SPRINGS LOFTS

RFI#: 37 Date: 1/23/2012 Job: EB-02 Keller Springs Lofts Phone: 877-777-5115

Date Required: 1/25/2012 Request: On sheet P-3.0C the main sanitary trunk line is shown running in the center of the corridors. It is 6" running north along the east side of the garage. It joins another 6" running east along the north side of the garage. So we have a 6" joining with another 6" but there is no designation as to the size of the line after that until it meets the 10" that leaves the building. Sheet P-3.0E gives no designation to the size of this line either. I feel this may be an oversight and the intention would be to have the large to an 8" after the (2) 6" lines merge. Please advice and respond as we are going to be installing these lines in the next two days.

Spec Section: Schedule Impact: None

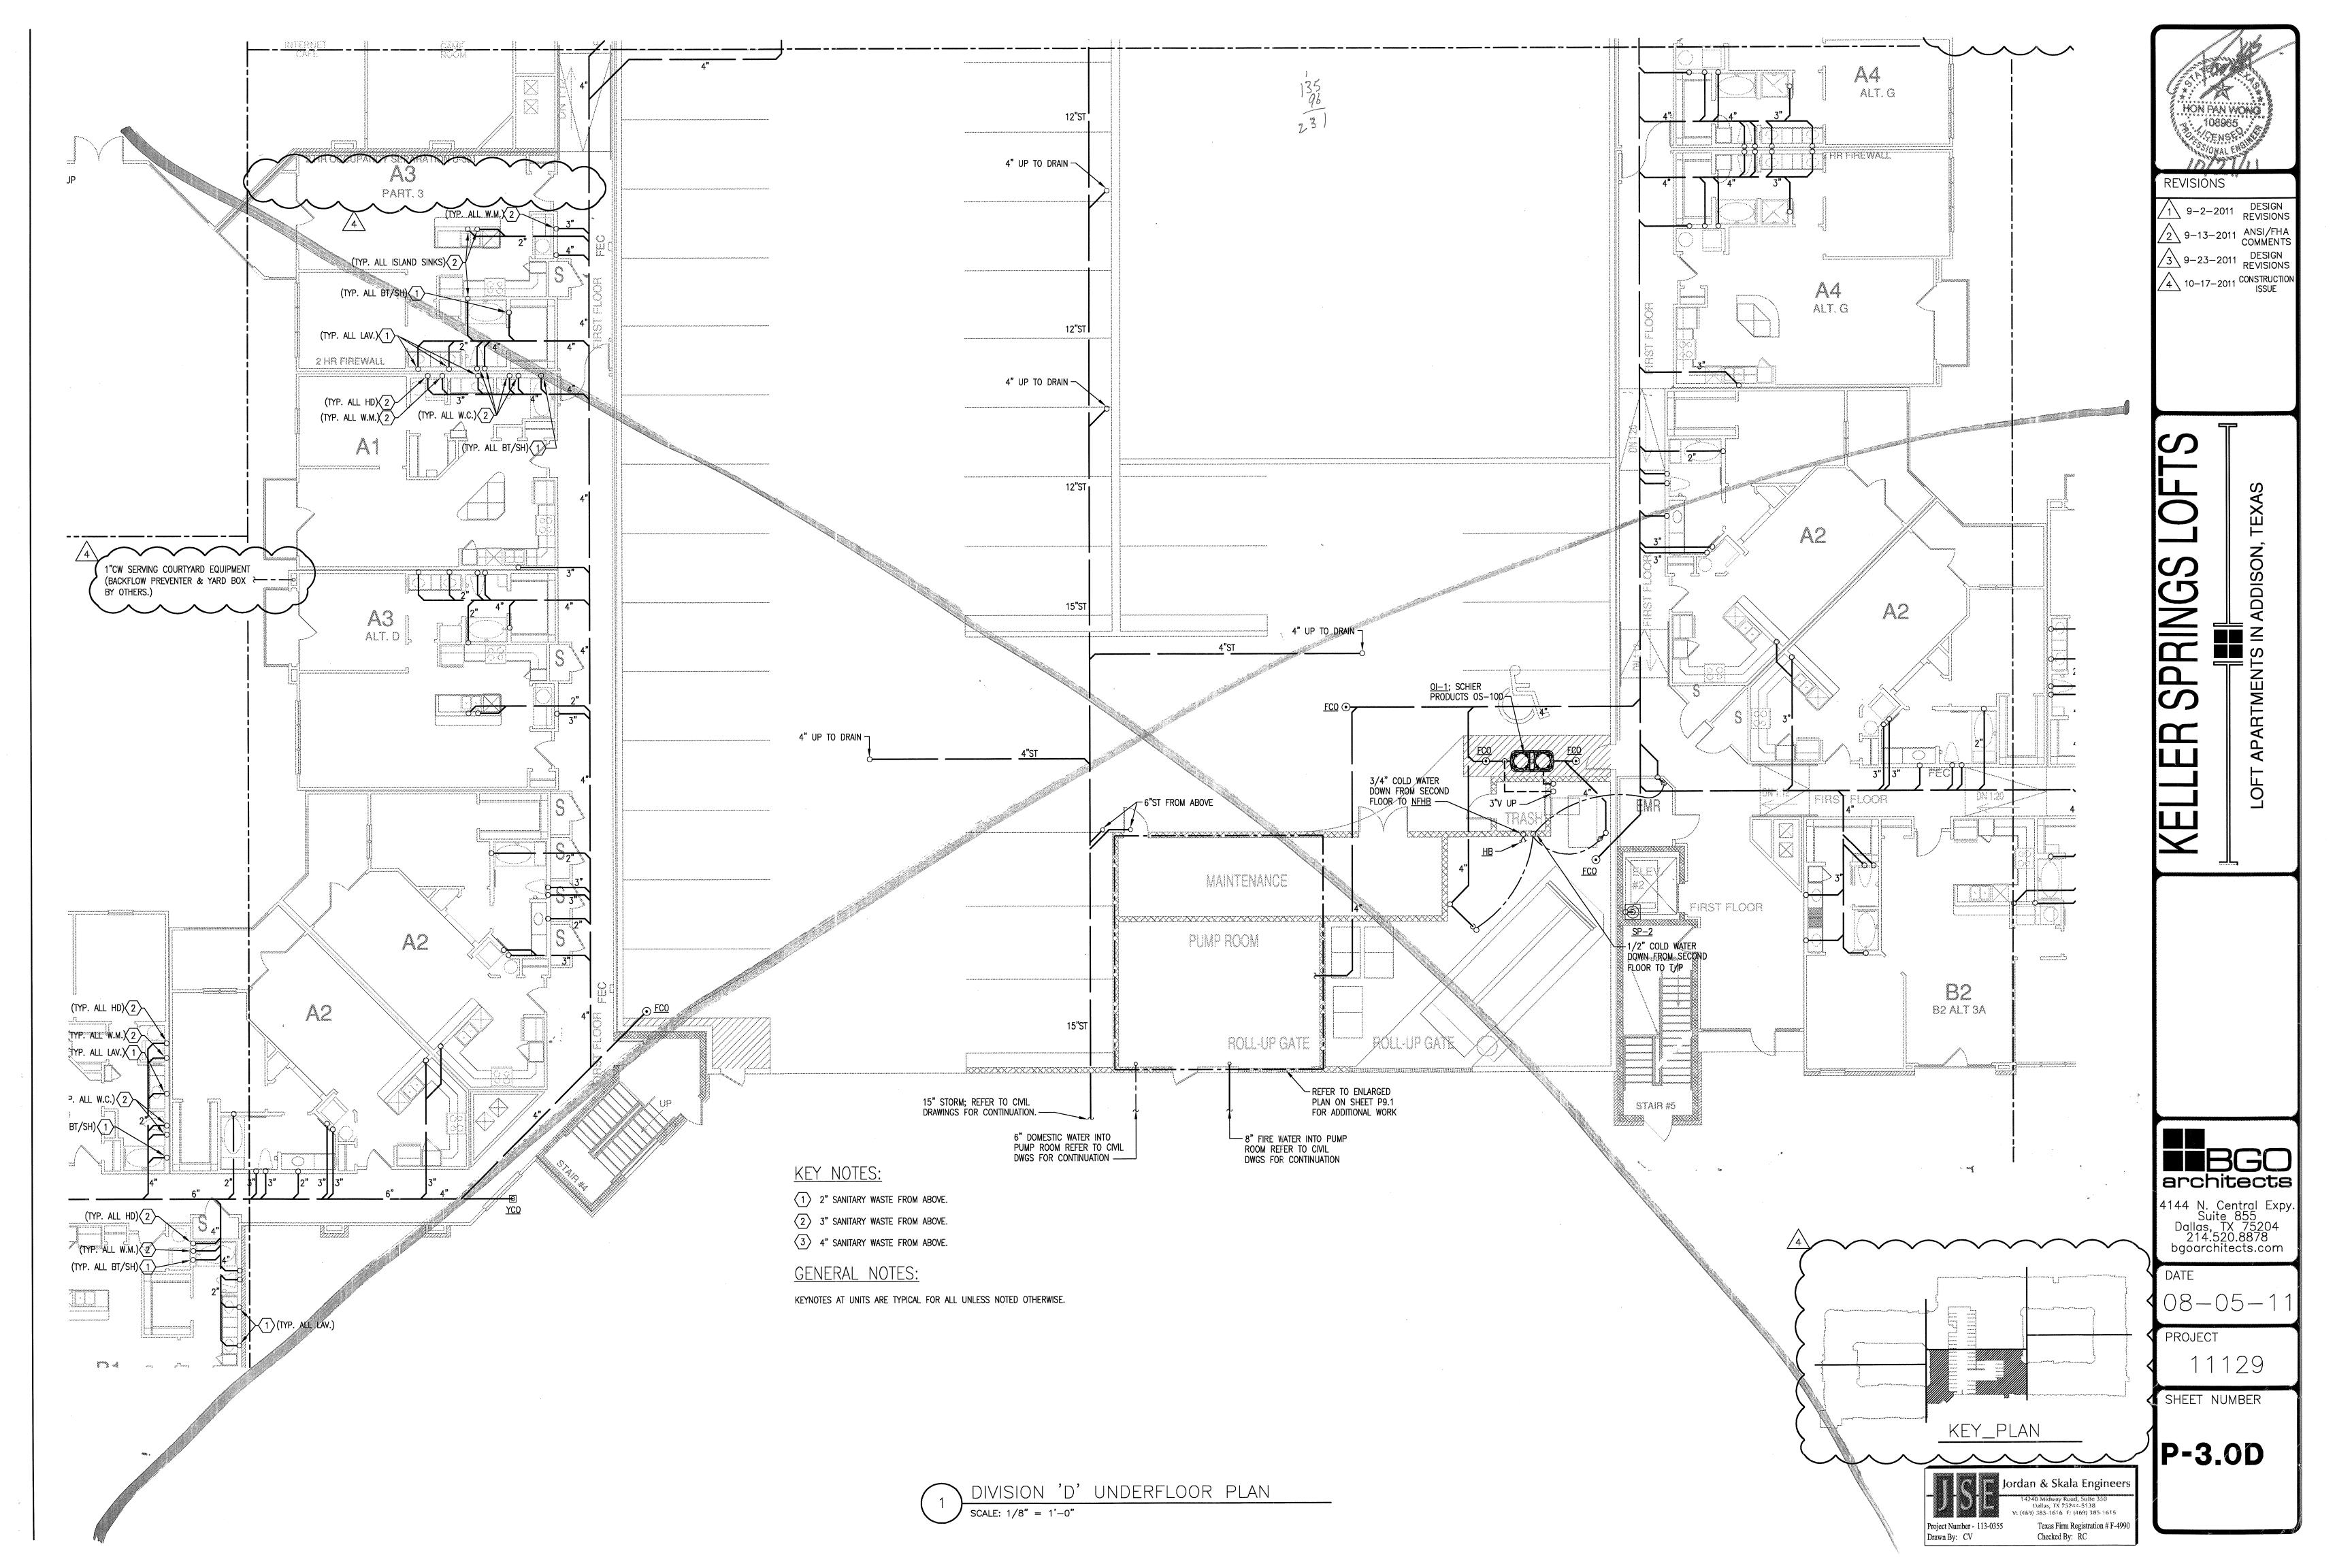
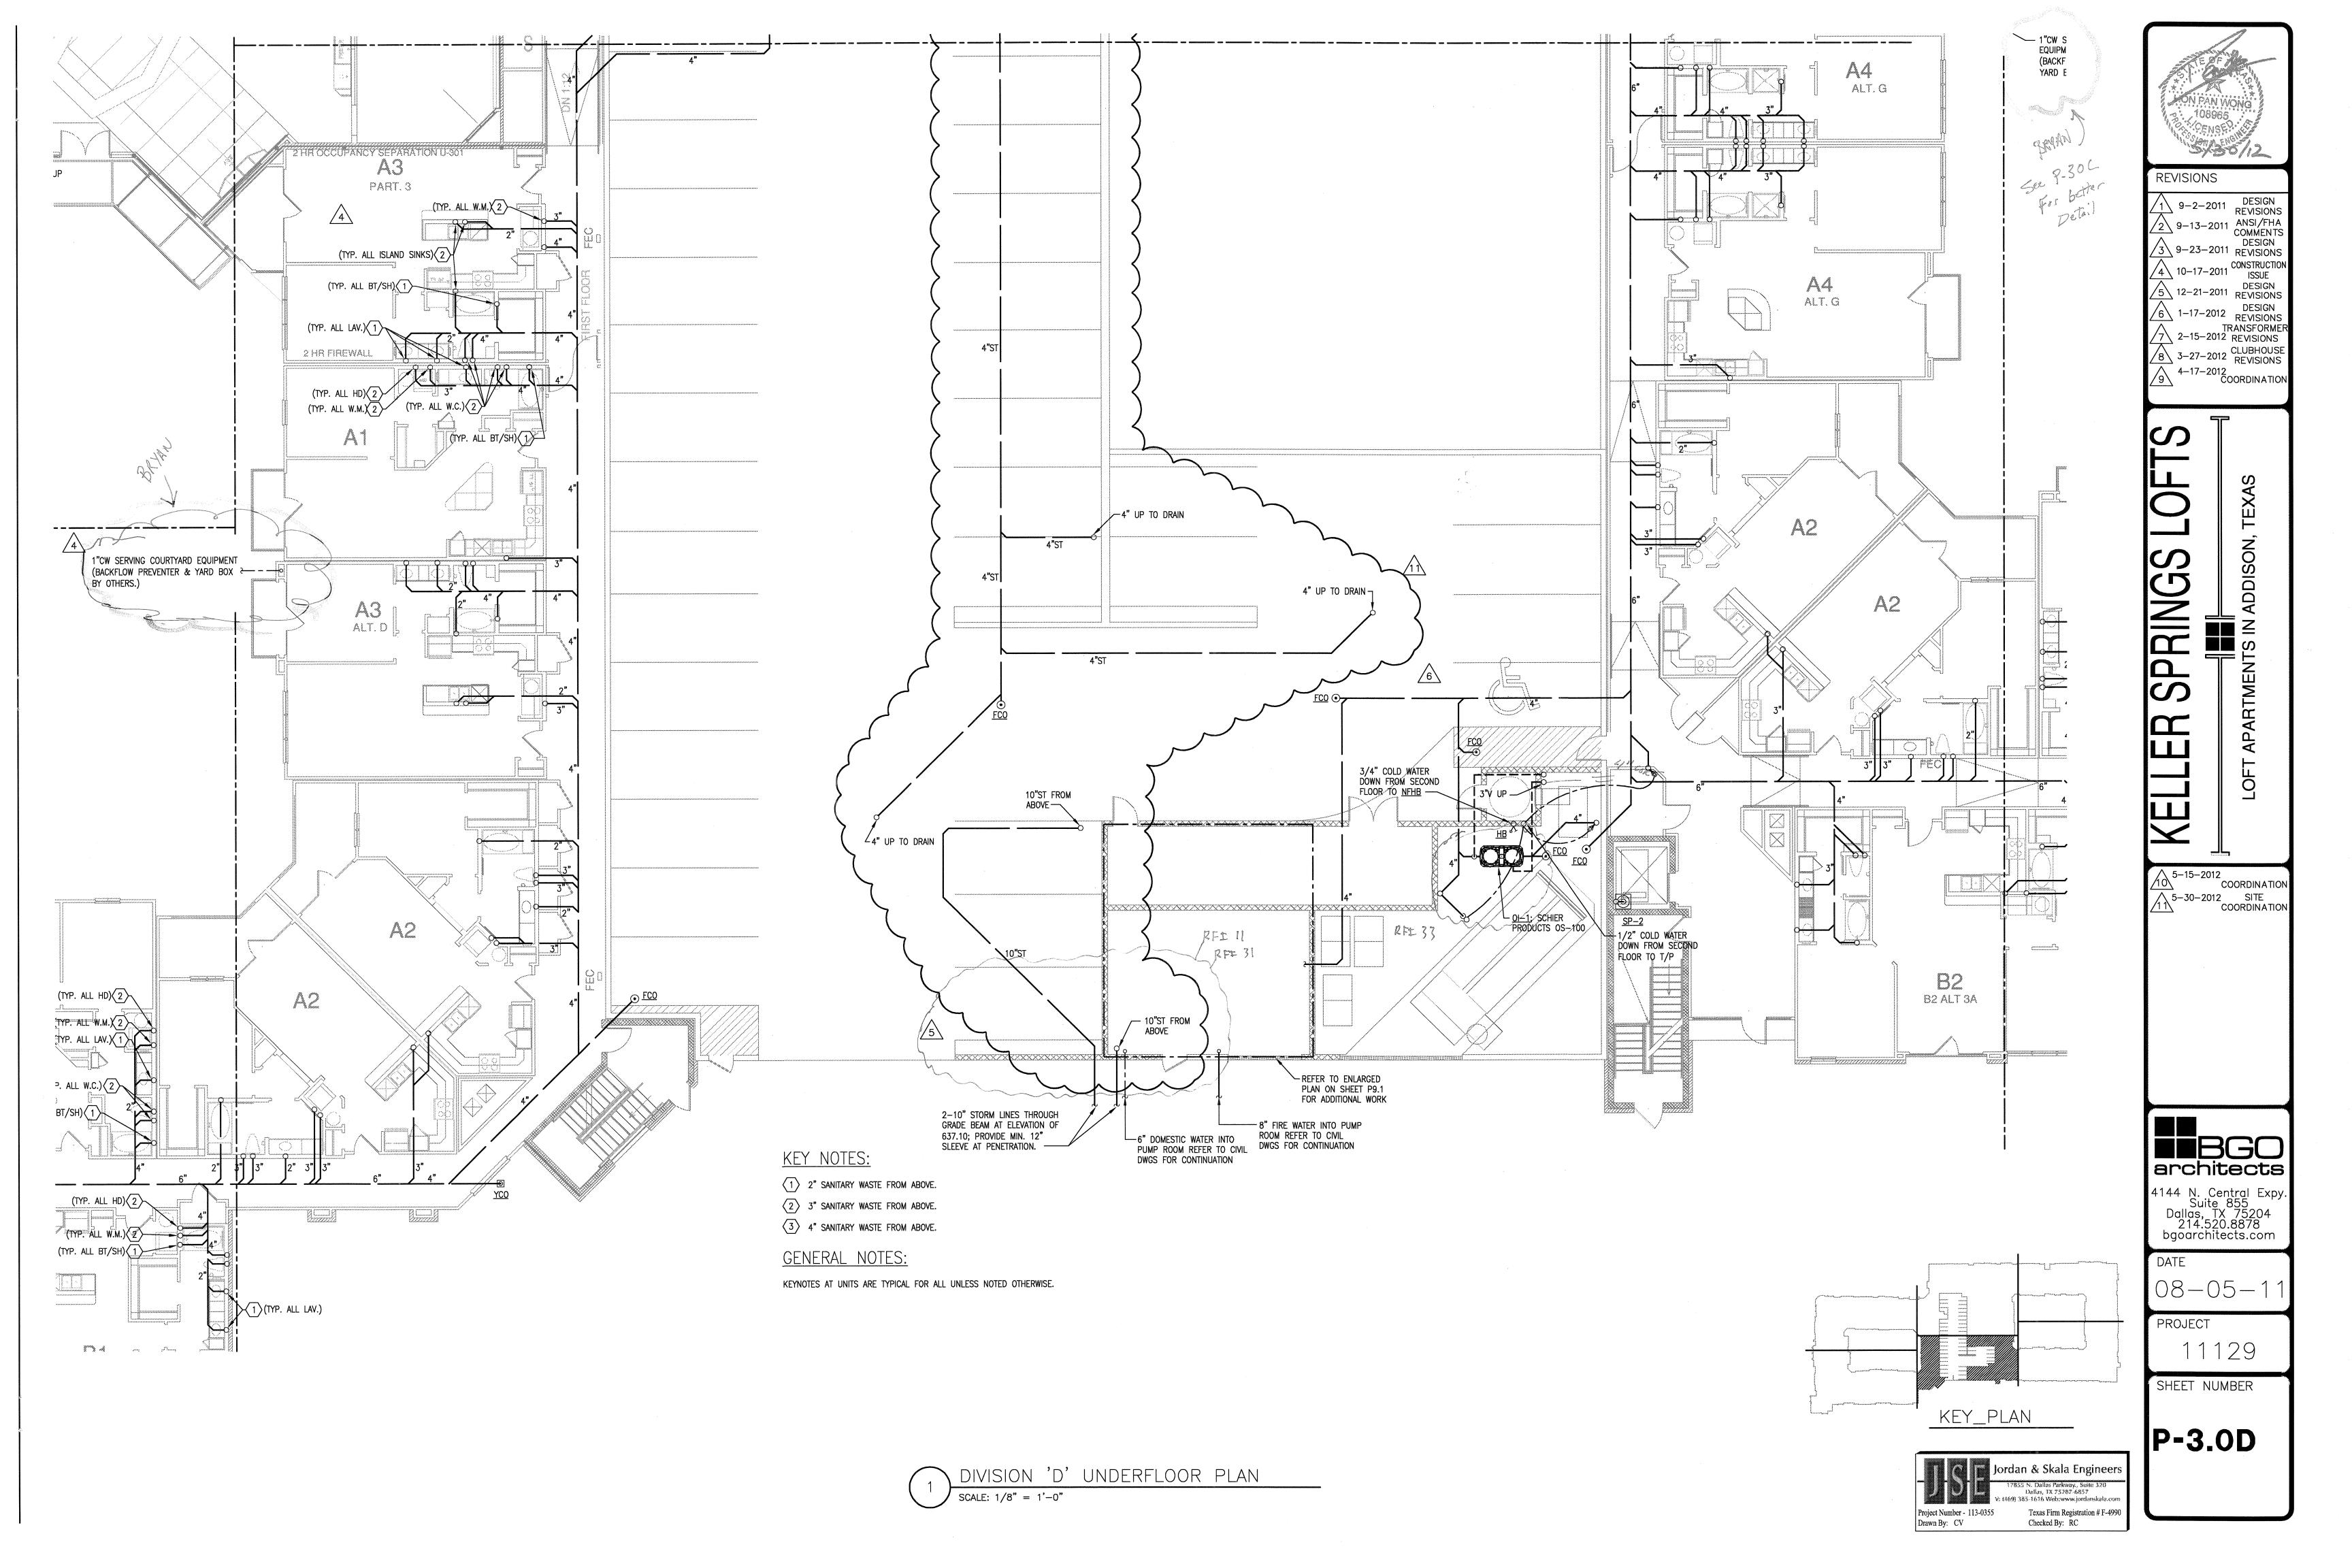
Sheet P-3.0D shows the OS-100 (oil separator) located in the resident walkway from the garage to the building. I believe this will almost certainly be a tripping hazard, and purpose we move its location to the trash compactor room. I have an attached detail showing the location my plumber and myself think would be an alternative location. Please review and advised Requested by: Bryan Pickler

Embrey Partners, Ltd. JSE takes no exception to the proposed re-location of the oil separator. New location will be reflected on Design Revision plans dated 01-17-2012 (Delta 6). Russell Cox - Jordan & Skala Company
